**NO_x RECLAIM BARCT
INDEPENDENT EVALUATION OF COST ANALYSIS
PERFORMED BY SCAQMD STAFF FOR BARCT IN
THE NON-REFINERY SECTOR**

**TASK 1a/1b/1c:
FINAL REPORT
NOVEMBER 26, 2014**

**SCAQMD CONTRACT NO. 15343
ETS, INC. CONTRACT # 14-1907-C**

Figure 1

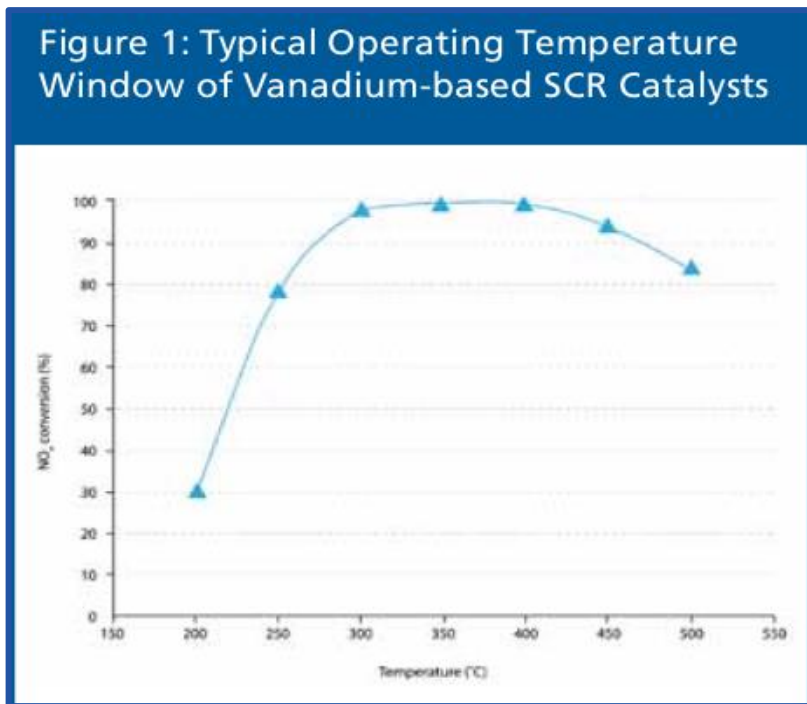
The proposed arrangement for operating 3 SCR units for the two furnaces is that an ESP/SCR combination can be taken off-line and another ESP/SCR combination can be brought on-line to keep the furnaces in operation. It must be pointed out that the removal efficiency of typical Vanadium-based SCR catalysts is highly temperature dependent (Figure 1¹). Accordingly, in the time period when the furnace gas stream is switched to an off-line SCR and the catalyst in the SCR reactor can be heated up to a proper operating temperature, the NO_x removal efficiency of the SCR may be below the design target.
